**PUBLIC INTEREST REVIEW FOR GROUNDWATER APPLICATIONS**

TO: Water Rights Section Date 3/31/2017  
 FROM: Groundwater Section Jen Woody  
 Reviewer's Name  
 SUBJECT: Application [REDACTED] Supersedes review of n/a  
 Date of Review(s)

**A. GENERAL INFORMATION:** Applicant's Name: Willow Creek Dairy c/o Greg te Velde County: Morrow

Figure 2. Water-Level Trends in Nearby Wells

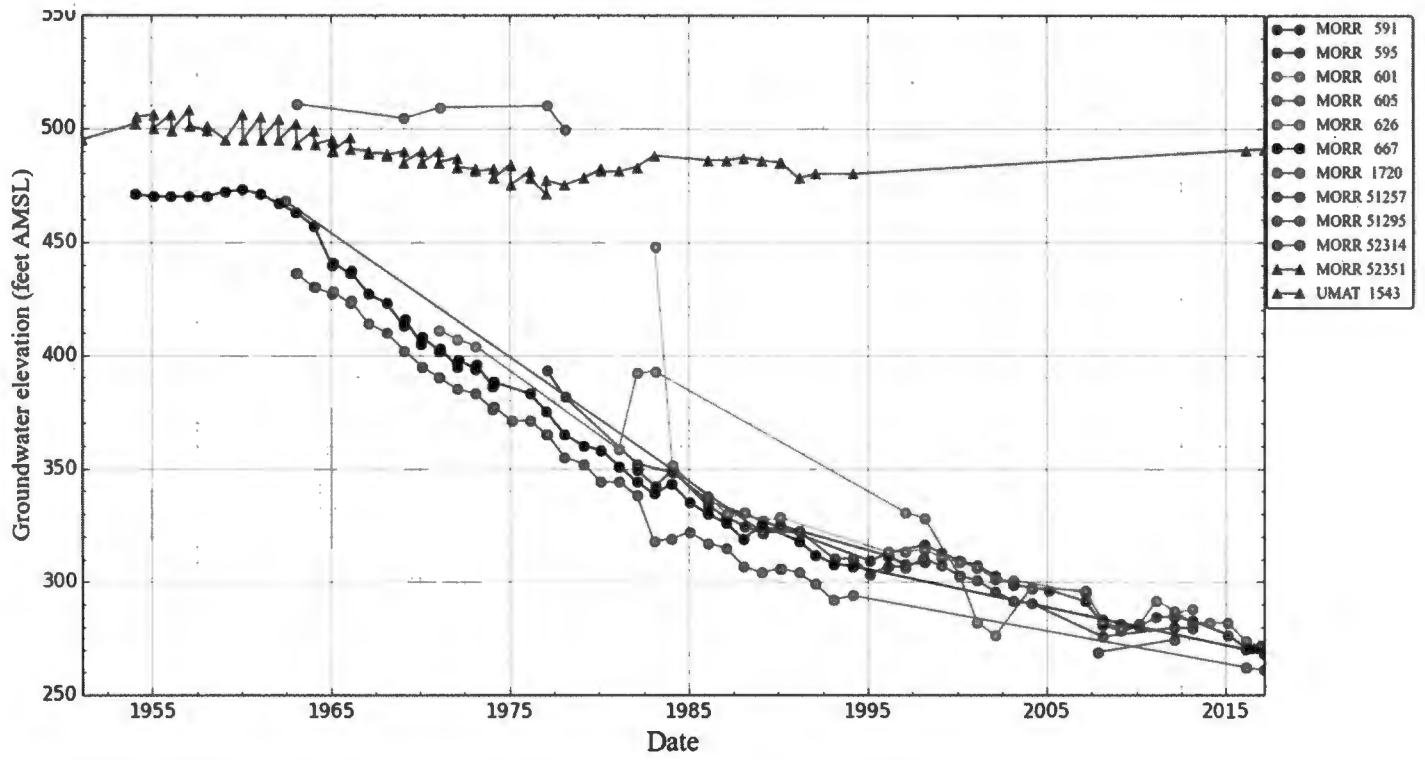
Hydrogeologic investigations by McCall (1975) found that at least two CRBG aquifers extend through the Ordance Basalt CGWA within 800 feet below land surface, each with a distinct head. Water level data collected since 1975 support that finding (see Figure 2). The new wells drilled at the subject site access a water-bearing zone below 400 feet, and have static water levels similar to other nearby basalt wells of similar depth.

The Ordance Basalt CGWA Order (1976) describes long-term groundwater declines in the deep basalt aquifers and prohibits new allocation. Declines within the deep basalt aquifers continue currently (see Figure 2) and indicate that withdrawal from the groundwater system exceeds recharge. These factors lead to the findings that the resource is over-allocated, and that new allocations are not available within the capacity of the basalt groundwater resource or without injury to senior users.

Observation well requirement. A minimum of one observation well shall be constructed to a similar bottom elevation as the production wells, and with a similar open interval. The observation well shall be at least 500 feet from all production wells, and shall be constructed by the applicant and maintained as a dedicated observation well for the duration of groundwater use on this property. The licensee shall obtain approval from a Department Hydrogeologist regarding well location and well completion details before and during well construction. The licensee shall grant Department staff access to install water level recording equipment and periodically measure water levels at the observation well. The Department shall evaluate groundwater level data for interference with other wells in the area and any changes to long-term water level trends.
